AP 164 Veranda St-I

Subject: Building permit for alterations in
the store at 164 Veranda Street

Subject: Application for building permit to cover alterations in store at 164 Veranda Street

Subject: Application for building permit to remove
partition between two stores 13 feet long at 164
Veranda Street

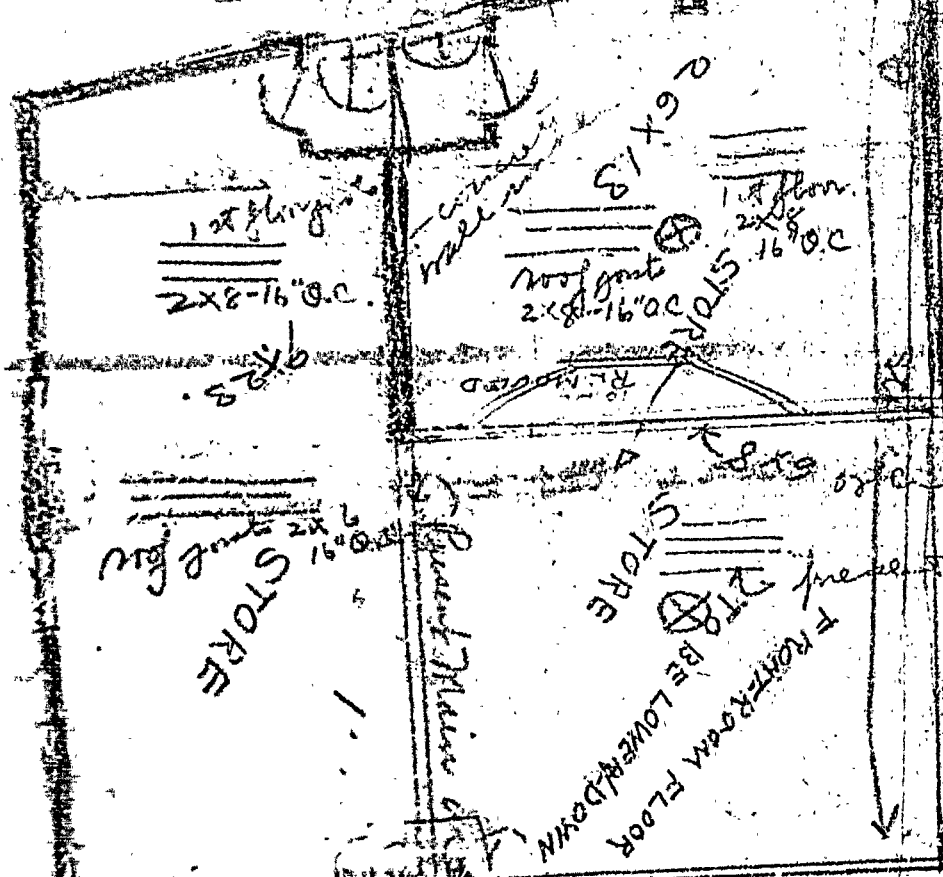
2. There is a cross-section on the latest plan by Mr. Farrington which seems to indicate that it is the intention to raise the floor of the store, supporting it at the new level on the puncheons. No mention of this change is made in the application for the permit, however, and there is not enough information on the plan to show compliance with the Building Code. It appears that the new floor joists would be intended to be on spans of 5 feet but the size and spacing of the floor joists are not shown. The floor at the new level is shown to be supported upon 2x3 puncheons with a single 2x3 plate over the top of the uprights. No less than 2x4 is to be used on any of this work. The plan should be revised to show full information including the use of 2x4's, the size and spacing of the puncheon and the floor joists, and if the floor joists are not to be directly over the puncheons then a double instead of a single 2x4 plate should be used at the top of the puncheon. This work of raising the floor level, if intended, is not included in the permit; but if the owner wants it done, the contractor should apply for an amendment to the permit covering the raising of the floor and with the application for amendment should be filed a blueprint of the revised plan showing all of the information.

7. I have just noted a note: "2x6 floor joists". Perhaps this means that the new floor joists of the raised floor are to be 2x6. If so, this fact should be shown clearly in the cross-section as well as the spacing of them, also how the new floor joists would be supported upon the exterior side walls of the building.
